FLIGHT READINESS STATEMENT
STS-66/ET-67 DELTA LEVEL III REVIEW
EXTERNAL TANK PROJECT

EXTERNAL TANK ET67, AS IDENTIFIED IN THE EXTERNAL TANK PROJECT DELTA FLIGHT READINESS REVIEW DATED OCTOBER 5, 1994, IS CONSIDERED READY TO SUPPORT FLIGHT UPON ACCEPTABLE DISPOSITION OF OPEN WORK AND/OR OPEN ACTIONS.

STS-66/ET-67 Flight Readiness Review

CAPS P-074 and P-075

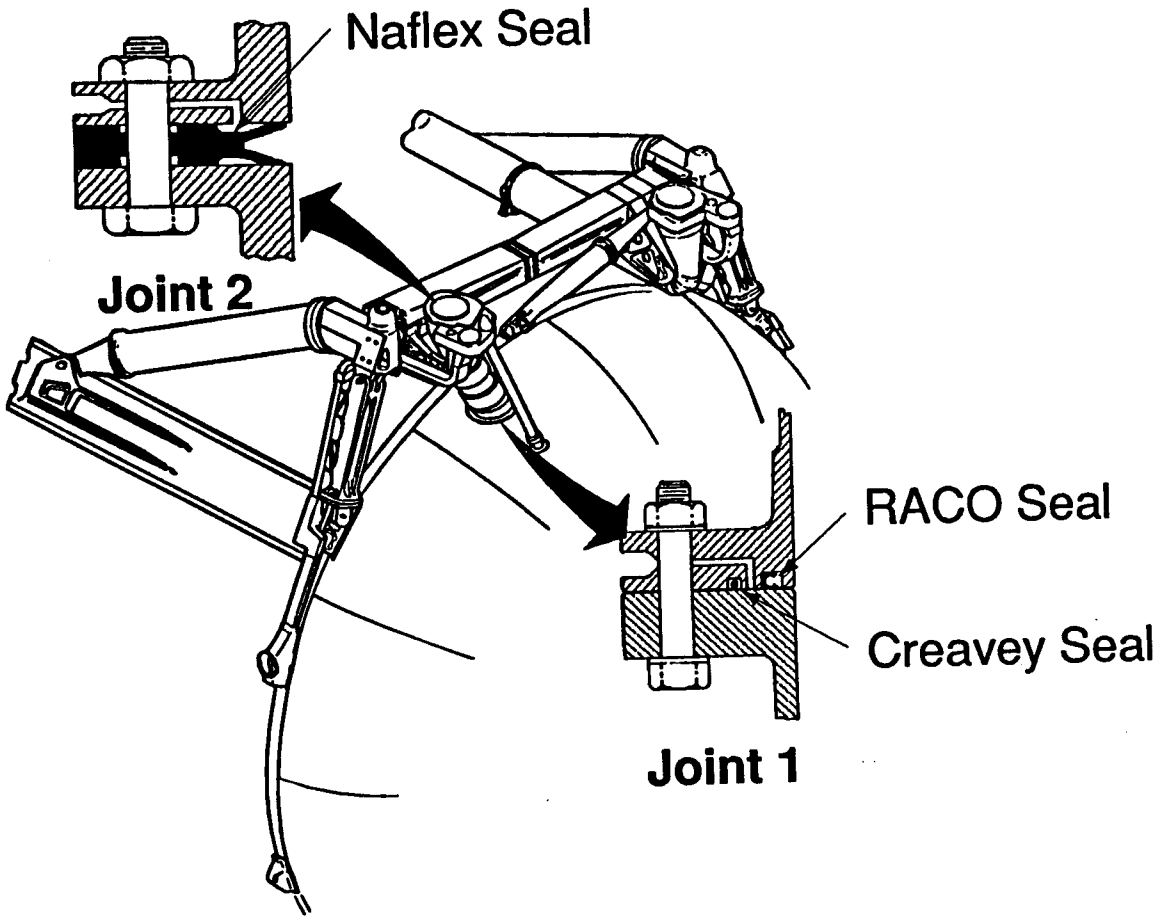
- ET-76 LH2 external feedline joint 1 (LH2 external feedline to LH2 tank) leaked at installation

- Anomaly discovered during dual seal cavity leak check at MAF
  - Seal used at this joint is a RACO (primary) and Creavy (secondary)
  - Trouble shooting revealed no test equipment malfunctions
  - No secondary seal leakage detected when Leak Tec applied to junction of flanges (tank and feedline)
  - The seals were removed and replaced and the joint was successfully re-tested
  - Two (2) flat spots approximately 90° apart were found on the removed RACO seal
  - Sample inspection of twelve (12) RACO seals revealed no indentations or leak paths

- Leak resulted from seal damage during installation, handling or supplier fabrication

- ET-76 LH2 external feedline joint 2 (LH2 external feedline to disconnect) leaked at installation

- Anomaly discovered during dual seal cavity leak check at MAF on ET-76
  - The seal used at this joint is a Naflex (Primary and secondary seals in a single unit)
  - Troubleshooting revealed no test equipment malfunctions
  - No secondary seal leakage detected when Leak Tec applied to junctions of the flanges
  - The seal was removed and replaced and the joint was successfully re-tested
  - Inspection of the removed seal showed no discernible discontinuities in the sealing surfaces

- Unknown - Root cause of the leak could not be determined

- Crew meetings held with appropriate installation personnel informing them of seal defect and effects of this type anomaly

- All ETs cleared - Isolated case
  - ETs 67 thru 75 sucessfully passed acceptance tests
  - ET-76 sucessfully passed acceptance test following replacement of seal
- ATP inspection is a positive screen for this condition

- No corrective action for this failure possible

- All ETs cleared - Isolated case
  - ETs 67 thru 75 sucessfully passed acceptance tests
  - ET-76 sucessfully passed acceptance test following replacement of seal
- ATP inspection is a positive screen for this condition

81L2 Electrical feedthru connector assembly

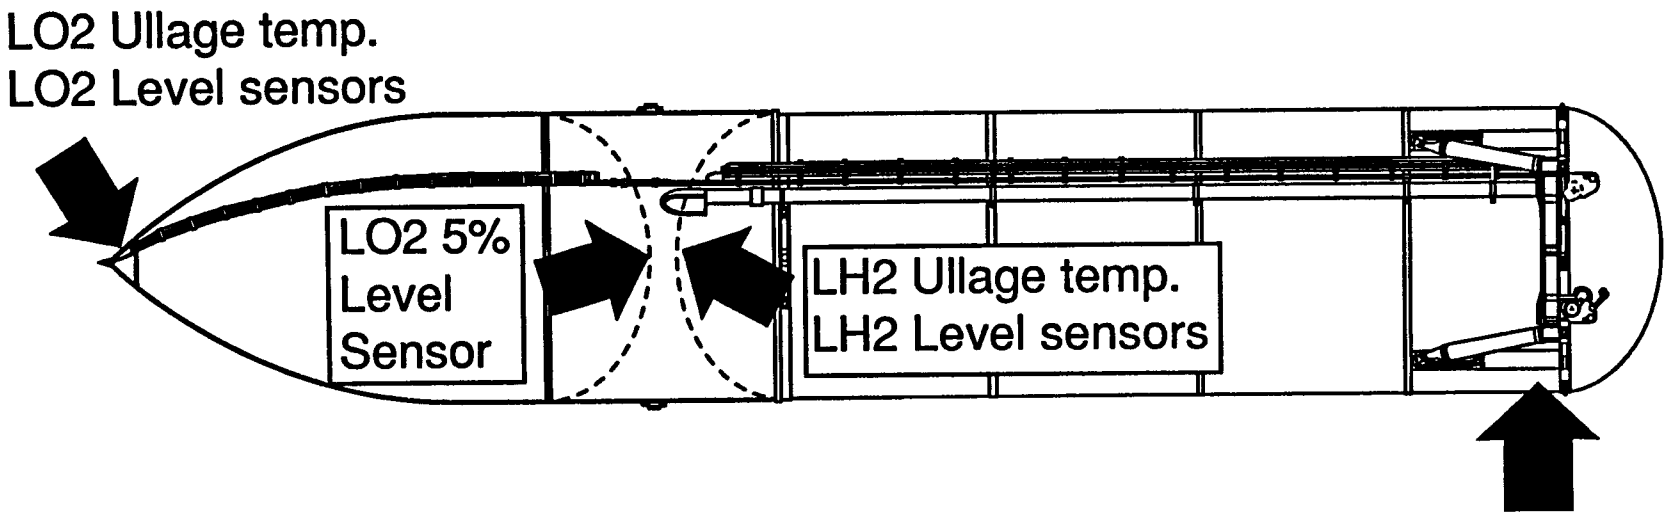
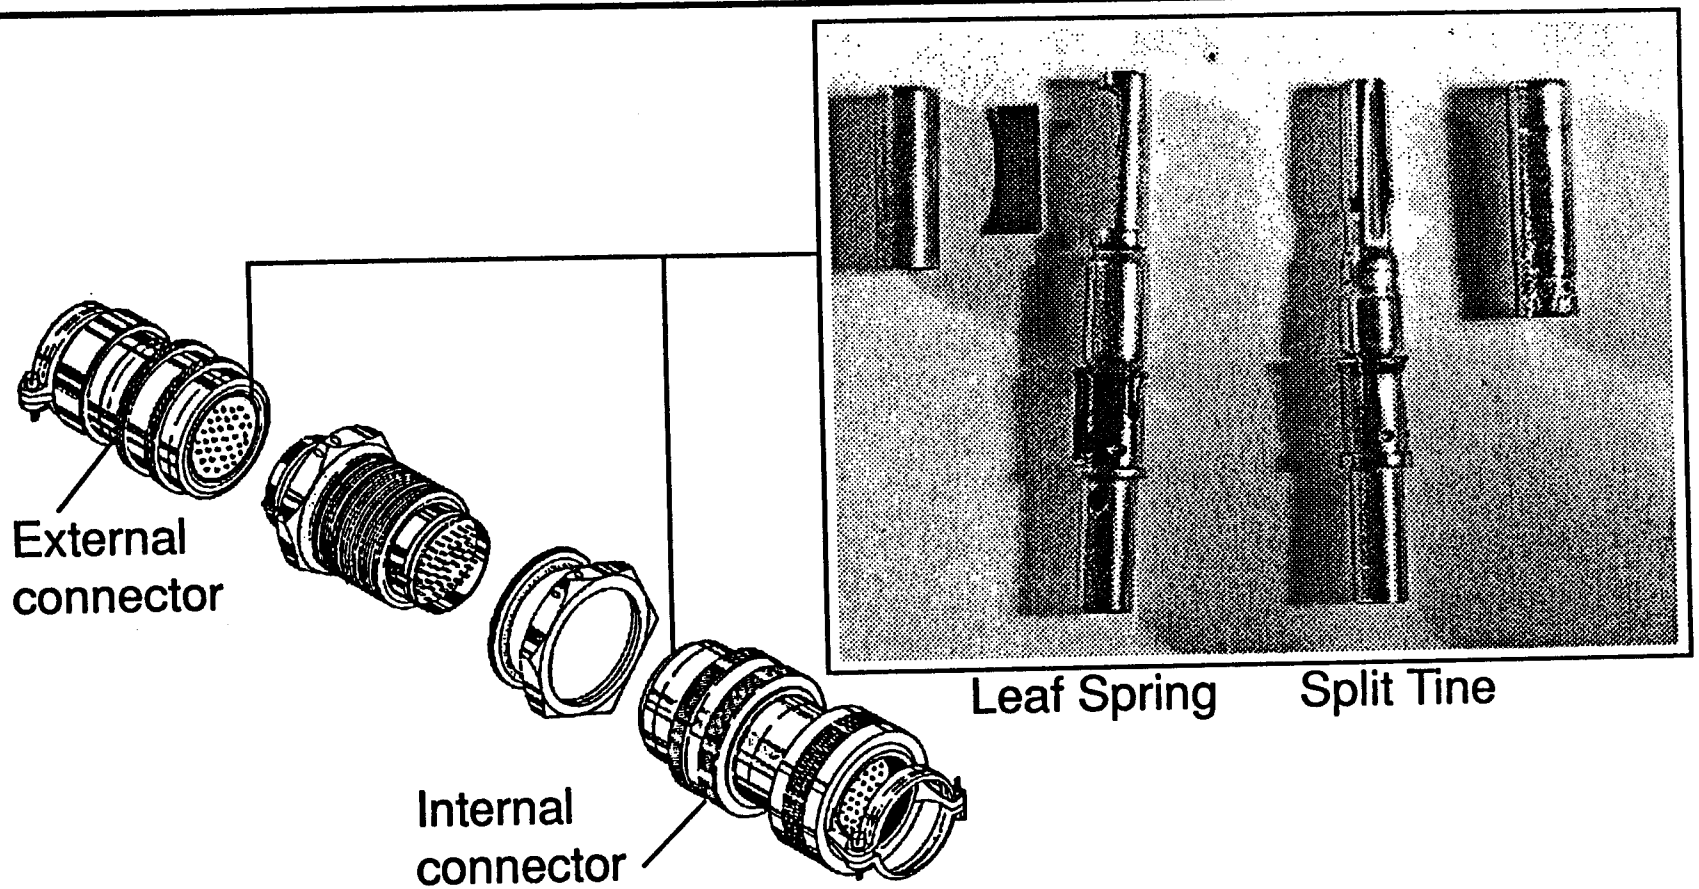
- 81L2 connector not manufactured to the qualified design

- Vendor connector design changes initiated in 1986
  - MMMSS team assessed changes as minor
    - Contact Socket design
    - Release mechanism wave spring
    - Glass material vitreous seal
  - Delta Qualification not performed
  - Most significant- socket design
- Qualified (-423°F) socket design utilizes leaf spring configuration
  - Spring -Barrel type with leaf spring installed inside for pin retention
    - Spring maintains pin barrel side contact
- Unqualified socket design utilizes 'split tine' configuration
  - Barrel is bifurcated spring at top edge
  - Top edge provides effective choke hold on pin
  - Simpler construction
  - More positive contact between socket & pin
- Qualification of ET 81L2 'split tine' connectors will be by Engineering Analysis & Similarity

- 'Split tine' is preferred configuration
- Socket/Pin retention test performed during fabrication
- 'Split Tine' sockets are qualified for use with ET General Purpose 40M connectors (Qualified to -250°F)
- Centaur qualified connector in 1992
  - Qualification loads more severe than ET @ -300°F
- Thermal assessment indicates more grip force between the pin & socket as temperature decreases
- 'Split tine' design has flown potentially on 5 ET's with no anomalies (ET's 61-64,66, STS-59,60,62,64,65,)
  - STS-68/ET-65 Launch scrub & detank
- LH2 ECO depletion sensors only criticality 1 circuit
  - Operational during ascent second stage
  - Engine Cutoff logic looks for 'dry' indications
  - Depletion sensors fail open-'wet'

- COQ Revised -Pending approval at MSFC
